# ENERGYSOLUTIONS

71-9168

**Subject: 10 CFR 71.95 Report on the 8-120B Cask**

## **Failure to Observe Certificate of Compliance Conditions for the 8-120B Vent Port Pre-Shipment Leak Test**

### Details of the 8-120B Vent Port Leak Rate Test Setup

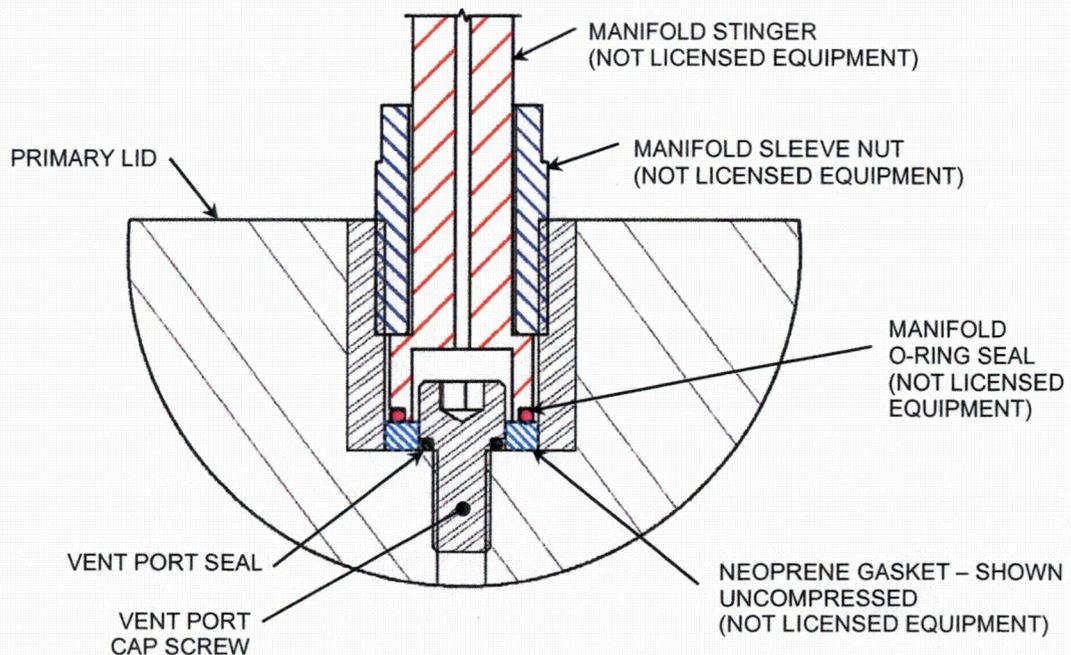
The pre-shipment leak test of the vent port is a pressure drop test performed using a dedicated test manifold. The test manifold is not a part of the licensed package. It includes a stinger (shown below), an O-ring seal that contacts the stinger and the bottom of the vent port hole, and a sleeve nut to compress the O-ring seal. The test manifold was designed so that it surrounds the vent port cap screw, leaving a small gap between itself and the vent port cap screw. The 8-120B cask fleet began to ship with a new lid design in September 2013, and operations staff noted more frequent difficulty getting the manifold to seal. It became desirable to find a better way to seal the bottom of the manifold in order to minimize operator exposure. They found that adding a neoprene gasket (also not part of the licensed package) under the base of the stinger as shown below helped reduce testing time and exposure.

The new manifold gasket design, shown below, replaces the manifold O-ring seal and neoprene gasket previously used with a neoprene gasket that fits within the notch at the base of the manifold stinger.

Corrective Action – Modified Test Seal
